UNITED STATES PATENT AND TRADEMARK OFFICE

09/471,981

Office Action Summary

DETAILED ACTION

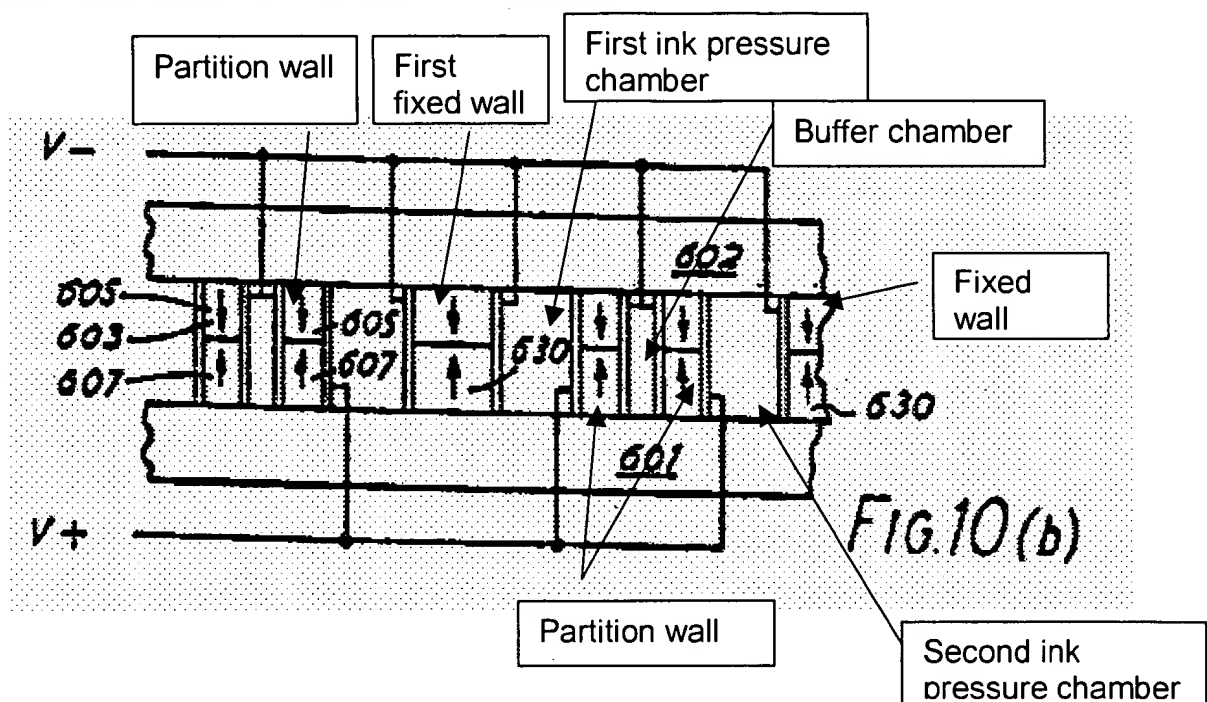
- an ink-jet recording head comprising at least one piezoelectric block (Fig.10b);
- Each piezoelectric block (B) has first and second ink pressure chambers (Fig.10b);
- each pressure chamber communicating with a nozzle, first and second partition walls (Fig.10b);
- each partition wall serving as a driving portion for one of the ink pressure chambers, each partition wall including a piezoelectric element and two electrodes (Fig.10b) for driving said piezoelectric element;
- a pressure buffer chamber and first and second fixed walls (Fig.10b);
- The first fixed wall, the first ink pressure chamber, the first partition wall, the pressure buffer chamber, the second partition wall, the second ink

pressure chamber, and the second fixed wall are arranged in sequence along a thickness direction (Fig.10b) and surface of the electrodes are oriented perpendicular to the thickness direction, the driving portion is polarized in the thickness direction and perpendicular to the surfaces of the electrodes (Fig.10b), at least one electrode for controlling, by bending of the electrode, whether the partition wall bend toward a side of the ink pressure chamber or bends towards a side of the pressure buffer

- a plurality of these blocks, arranged in the thickness direction.
- the pressure buffer chambers are all closed on a side at which the nozzle communicating with the ink pressure chamber is open (Fig.10b).
- there are two electrodes per partition wall, one of which is exposed to the pressure buffer and the other exposed to the ink pressure chamber;
- a portion at which the electrodes on a partition wall face each other is included in a portion at which the ink pressure chamber and pressure buffer chamber face each other (Fig.10b);
- the piezoelectric block is an integrally sintered one piece block structure;
- the distance between nozzles appears to be constant (Fig.10b).

However, Bartky fails to teach at least one of the electrodes is embedded in the wall;

Takuchi et al. show that the electrode is between the piezoelectric portion and embedded in the piezoelectric portion is an equivalent structure known in the art. Therefore, because the electrode is between the piezoelectric portion and embedded in the piezoelectric portion were art recognized equivalents at the time the invention was made, one of ordinary skill in the art would have found it obvious to substitute the electrode is embedded for electrode is in between.
